AGENDA ITEM: 5.3

To: Development Assessment Panel (DAP) on 2 March 2015

Proposal: Three Storey Residential Flat Building comprising 6 dwellings (DA 050/466/2014)

Address: 172 Churchill Road, Prospect (CT 5200/971)

DWG NO. CHU-LT77-14.dwg

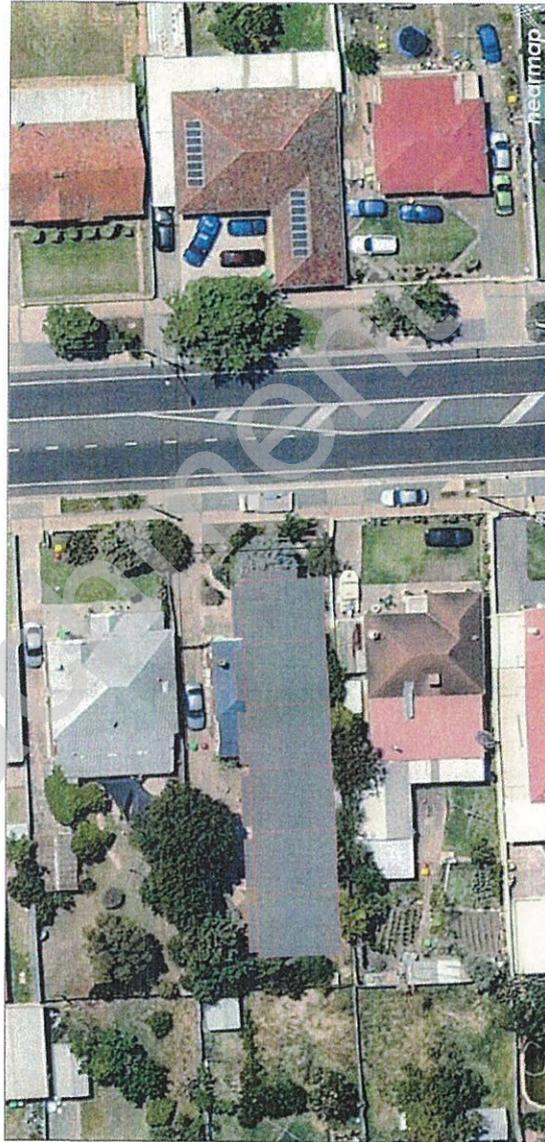
The application proposes to accommodate all access via a single shared access located adjacent the northern boundary of the site. The access is located in proximity to the start of the right turn storage lane for movements into Bosanquet Avenue. In order to minimise conflict with vehicles storing within the through lane on Churchill Road to turn right into the proposed access and vehicles entering the right turn storage lane (heading north), it is strongly recommended that the access be relocated to adjacent the southern boundary. This will provide a short area of painted median for vehicles to store clear of the through lane and not disrupt the free flow of traffic.

DPTI is concerned that vehicles will not be able to conveniently reverse from the proposed garages of dwellings 3 and 5 without conflicting with visitor parks located within the main driveway, particularly given the narrow garage door widths (2.7 metres) and 5.7 metres apron width. It is pointed out that AS/NZS 2890.1:2004, Figure 5.4 Apron Widths for Right Angle Access to Single Vehicle Garages recommends that where a 2.7 metres wide garage door is proposed the apron width needs to be 6.3 metres (or 6.0 metres with 150 mm kerb in height). DPTI considers the proposed design to be insufficient to allow convenient reversing movements and as such may encourage reversing movements onto Churchill Road which is considered highly undesirable. Furthermore, DPTI does not support the location of the visitor parks as there is no shared manoeuvring area whereby these vehicles can achieve on-site reversing movements and thus will result in reversing movements onto Churchill road. Subsequently, DPTI does not support the proposed design.

The applicant has provided an amended plan (refer Damien J Griffen Designs, Site Plan, Drawing No. CHU-T77-14, Sheet 6 of 9, amended 13/2/15) which incorporates the design issues raised in DPTI previous correspondence (dated 6/1/15); in particular, providing a shared access adjacent the southern boundary to reduce

disruption to the free flow of traffic on Churchill Road, providing a clear 6.0 x 6.0 metre area to allow simultaneous two-way vehicle movements and providing sufficient area for vehicles to achieve forward entry and exit. In-principle, DPTI is satisfied with the amended plan dated 13/2/15.
